N59 Oughterard Footbridge

Stage 1 Road Safety Audit

This report describes the findings of a Stage 1 Road Safety Audit associated with the N59 Oughterard Footbridge.

Figure 2.1 – Cyclist & Walkers Crossing Without Due Care & Attention

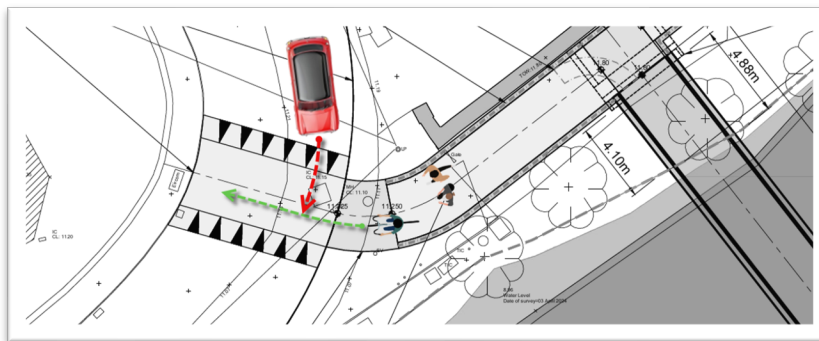
2.1 Problem: Walkers & Cyclists Crossing

Location: Shared Footpath Approach to Raised Pedestrian Crossing

Some walkers and cyclists may carry momentum and step straight from the new shared footpath onto the crossing without checking for approaching vehicles. This could lead to conflicts between vehicles and vulnerable road users on the crossing.

Recommendation

Chicane gates (or kissing gates) should be installed on the approach to the crossing to mitigate the risk described.

2.1	Yes	Yes	<p>Please see the attached general arrangement drawing which shows the following measures to address this problem:</p> <ul style="list-style-type: none"> - Longer landing (5m) between the end of the north ramp and Carrowmanagh road. - Planter added between the end of the end of the north ramp and Carrowmanagh Rd.

Figure 2.3 – Location of Northern Crossing of Local Road (Left) and N59 Crossing (Right)

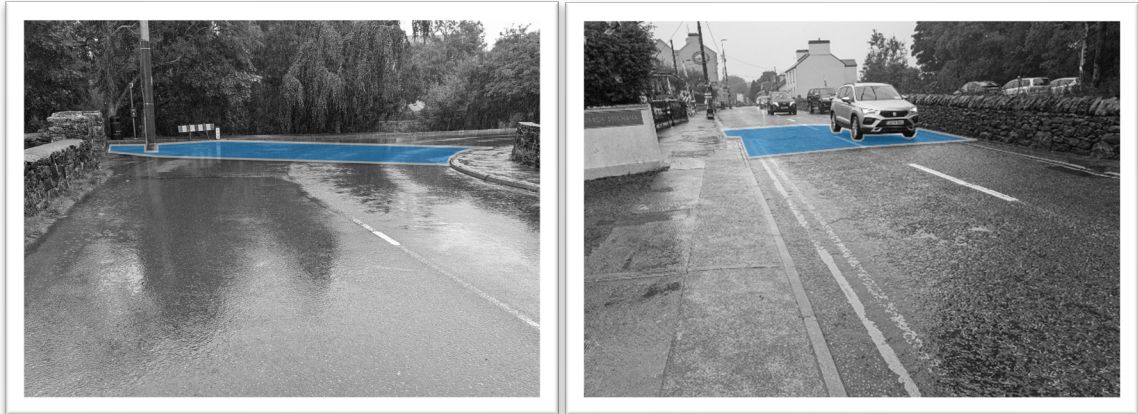
2.3 Problem: Vehicles Failing to Stop for Crossing Pedestrians

Location: Both Raised Pedestrian Crossings

Drivers are less likely to stop and give way to pedestrians on the uncontrolled crossings during commuter peak hours, when traffic flows are higher and the urgency for them to arrive at work on time is increased. This could lead to progression issues for pedestrians at the crossings (including school children and the mobility impaired) and conflicts between vehicles and vulnerable road users.

Recommendation

Appropriate control measures should be installed on the crossings with the intention of prioritizing the progression of pedestrians over the passage of vehicles.

2.3	Yes	Yes	<p>Please see the attached general arrangement drawing which shows zebra crossings to address this problem.</p>
